**Unconfirmed Minutes**  
**IEEE 802.3 CSMA/CD PLENARY**  
**Austin, TX**  
**November 12-15, 2001**

Figure 40-9

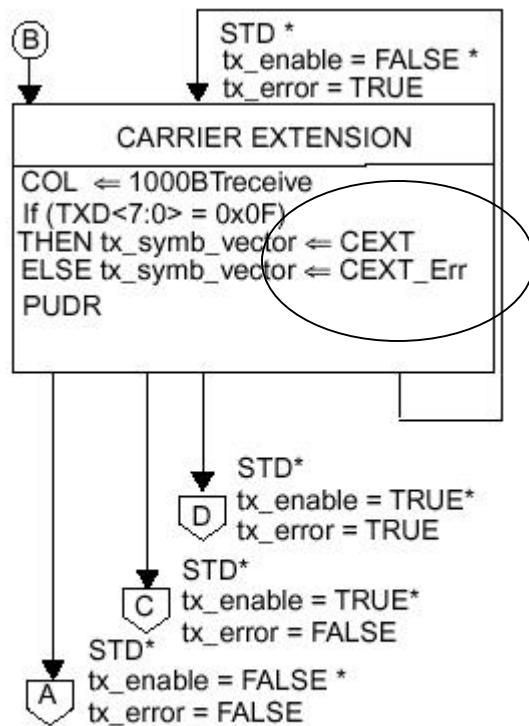
## Question 1, Clause 40.3.1.3

So the question is : what symbols does one transmit on the 4-twisted pairs to denote CEXT\_Err ?

**Relevant Clause:** Figure 40-9

The standard clearly defines CEXT and CEXT\_Err in the variables definition for Figure 40–9, subclause 40.3.3.1 ‘State variables’ as follows:

It is however noted that the reference is not as tight as it could be and a maintenance change has been raised to make the reference more specific. This change request is available at the URL <http://www.ieee802.org/maint/requests/all.html>

Figure 40-10a

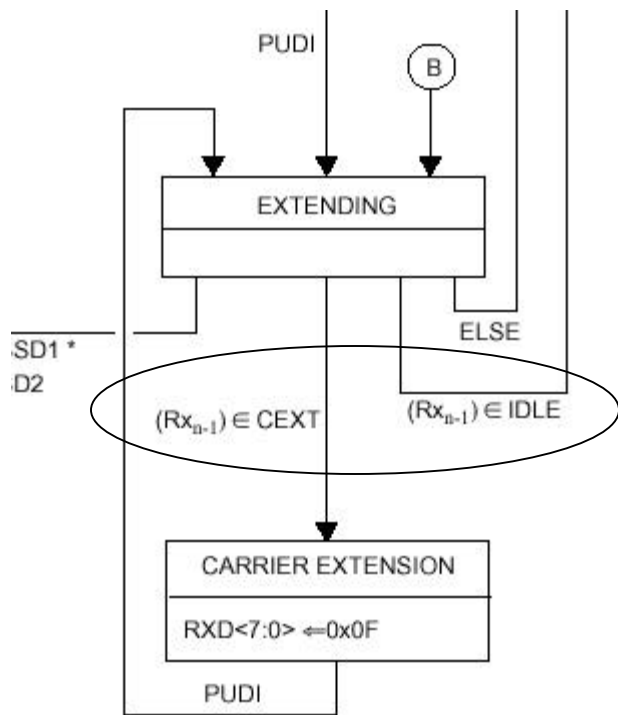
So the question is : In the Rx-path how does one differentiate between Idles/CEXT/CEXT\_Err in table 40-1?

Seems to be dependent on  $Sd(n)[1:0]$  ?

**Relevant Clause:** Figure 40-10a

The standard clearly defines CEXT and IDLE in the variables definition for Figure 40–9, subclause 40.3.3.1 ‘State variables’ as follows:

the standard clearly states in 40.3.1.4 PCS Receive 'To achieve correct operation, PCS Receive uses the knowledge of the encoding rules that are employed in the idle mode.'

Figure 36-7b

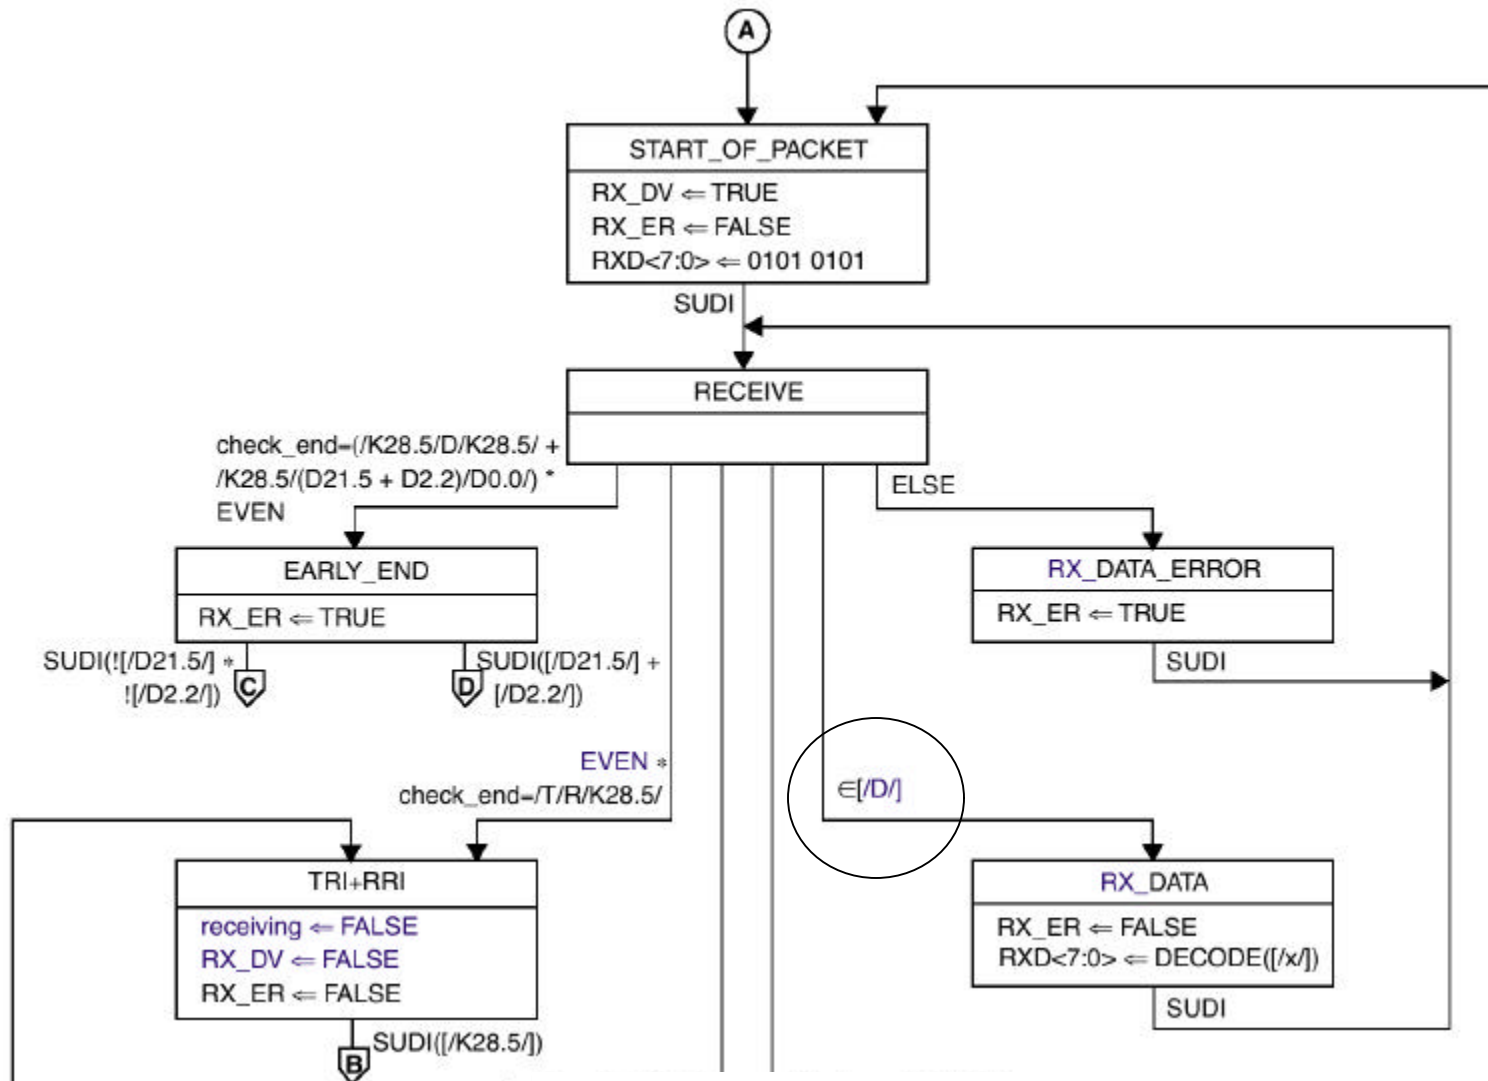
Where /D/ is a constant defined as representing the set of data code groups. The problem is that there is nothing on the transition to indicate what is being tested. Normally, the notation would be similar to that used on the left exit from RX\_CB in Figure 36-7a. SUDI(<element of symbol>[/D/]) where it is clear that the

I believe that the intent of the state diagram is that the test be against the code-group contained from the SUDI that cause the transition to RECEIVE. The notation that is used on the exit from RX\_CB can't be used here because the SUDI has already been used to transition to RECEIVE. One way to clarify the notation would be to add to the RECEIVE state an assignment of the parameter from the SUDI to a variable which can be tested in the transition condition. Another alternative is to add text to the description of the receive state machine explaining the deviation in the notation.

**Relevant Clause:** 36.2.4.2.2 Figure 36-7b

The analysis of this state machine transition provided in the request is correct however this has illustrated a lack of clarity of the conditions for this transition. A change request has been generated to correct this which is available at the URL <http://www.ieee802.org/maint/requests/all.html> and this request will be included in the next maintenance ballot.
